Service Bulletin

Bulletin No.: 23-NA-135

Subject: Information on Oil Level Control Changes and Compatibility on 2023-2024 9-Speed Transmissions

6396977

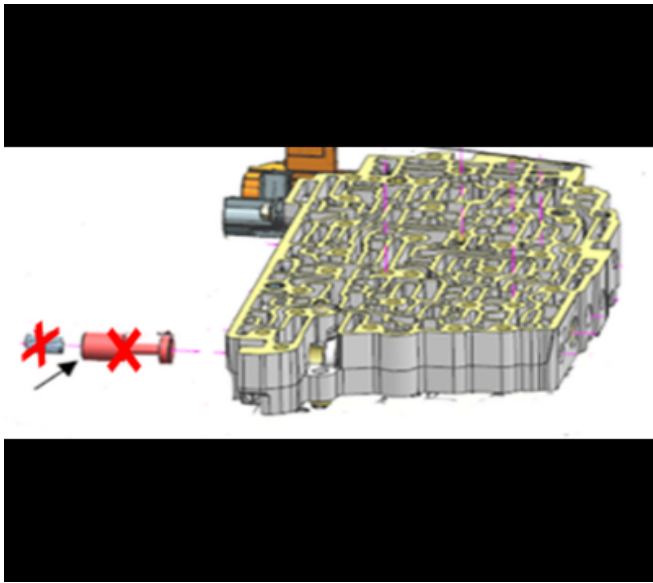
The previous a/trans fluid level control valve (1) on the stall pipe (item #21) had a small thermal door. The new style can be recognized by the larger thermal door (2) on the stall pipe.

6396979

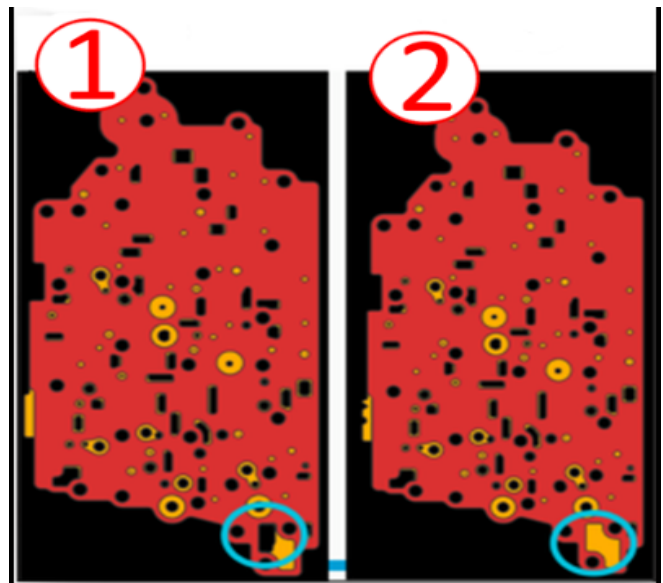
The valve body will eliminate the a/trans fluid valve (item #437).

6397367

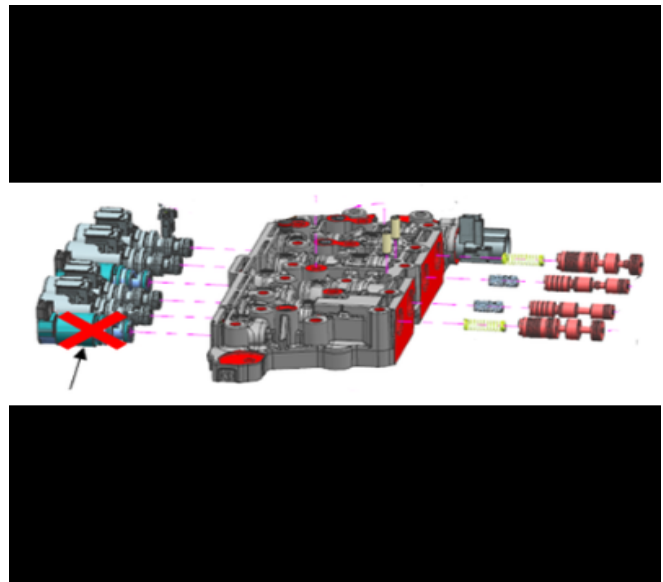
The valve body to transmission case spacer plate is covering over the port (item #456).

6397498

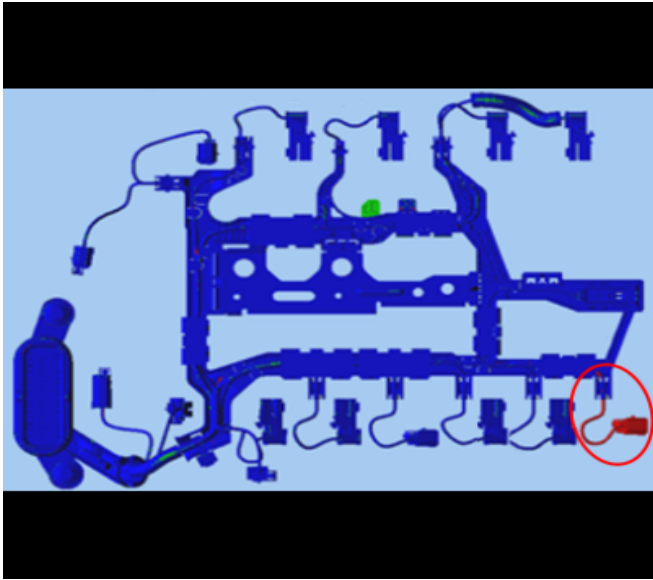
The solenoid body will eliminate the a/trans fluid control solenoid (item #403).

6397504

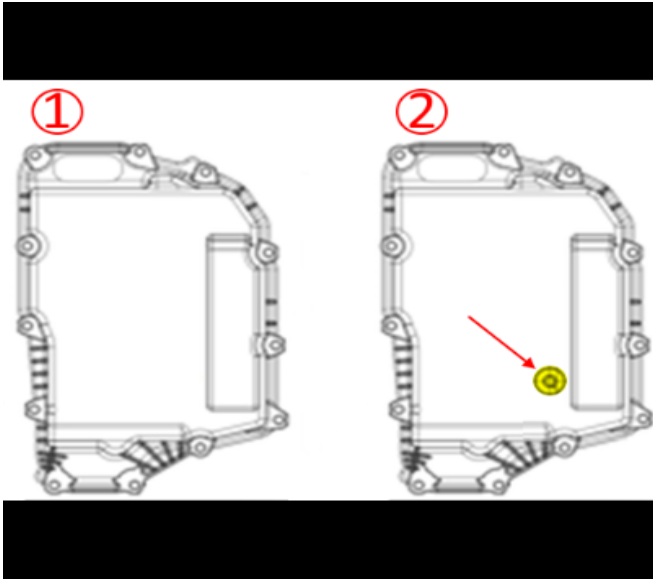
The a/trans wiring harness will eliminate the wire for the a/trans fluid control solenoid (item #31).
